5 SUB2010-00144

NEWCASTLE LANDING SUBDIVISION

APPLICATION	NUMBER 5 DATE January 6, 2011	N
APPLICANT_	Newcastle Landing Subdivision	_ {
REQUEST	Subdivision	_ ()
		NTS

DETAIL SITE PLAN

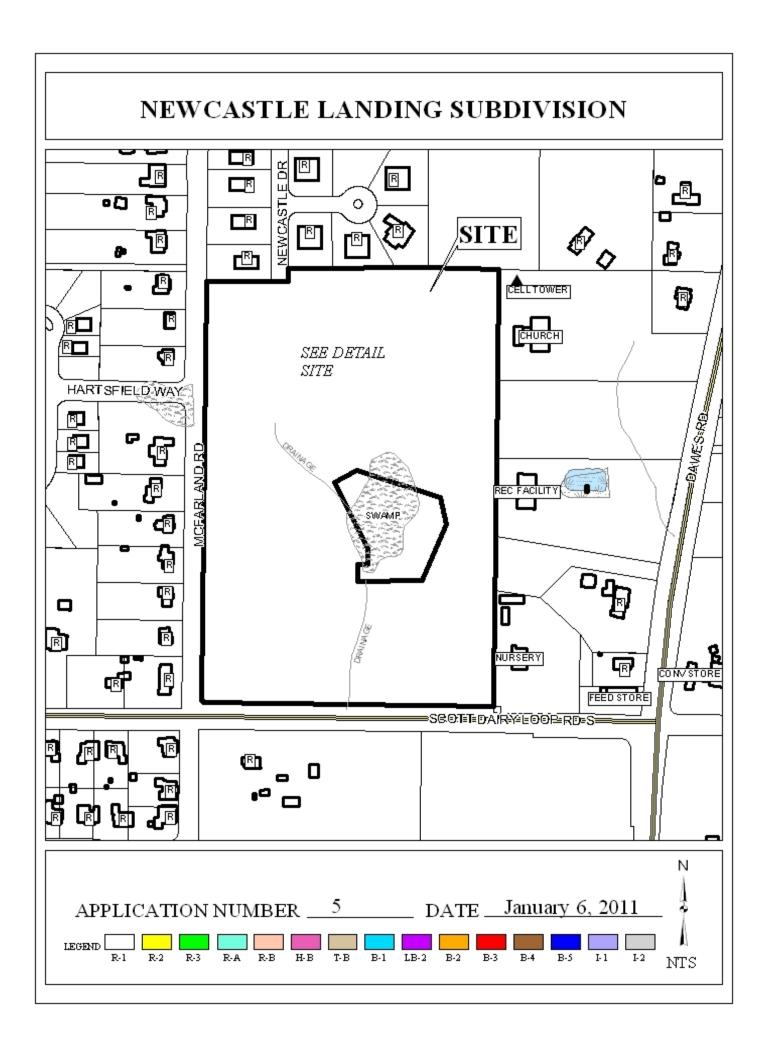
The purpose of this application is to modify a previously approved phase of a subdivision to alter a proposed connection to an adjacent subdivision. The site was most recently approved by the Planning Commission at its November 4, 2010 meeting as being joined to the Newcastle Estates subdivision to the North by extending Newcastle Drive. The newly revised plan proposes that instead of continuing the Newcastle Drive in Newcastle Estates, that there be a cul-de-sac, making the two subdivisions independent of one another.

When the Newcastle Estates subdivision was approved at the Planning Commission's July 1, 2004 meeting, it included development plans for the currently proposed Newcastle Landing subdivision. The currently developed Newcastle Estates was constructed with this connection in mind; therefore Newcastle Drive was not made to be a cul-de-sac as would normally be required by the International Fire Code and Section V.B.6. of the Subdivision Regulations.

As per Section V.B.1. of the Subdivision Regulations, the street layout shall be devised for the most advantageous development of the entire neighborhood or neighborhoods in which the land to be subdivided is located. Existing streets that abut the subdivision shall be continued, and the continuations shall be at least as wide as the existing streets and in alignment with them. The street layout shall also provide for the future projection into unsubdivided lands adjoining of a sufficient number of streets to provide convenient circulation.

The 25-foot minimum building setback is shown and labeled on the preliminary plat, and should be retained on the Final Plat.

The lot sizes are labeled on the preliminary plat with the sizes in square feet, and should be retained on the Final Plat, if approved. The lot sizes seem to be comparable to the existing lots in the Newcastle Estates subdivision to the North.

- 1) Lack of compliance with Section V.B.1. of the Subdivision Regulations, regarding street connectivity; and
- 2) Lack of provision of a cul-de-sac for the proposed dead-end of Newcastle Drive, as required by Section V.B.6. of the Subdivision Regulations.
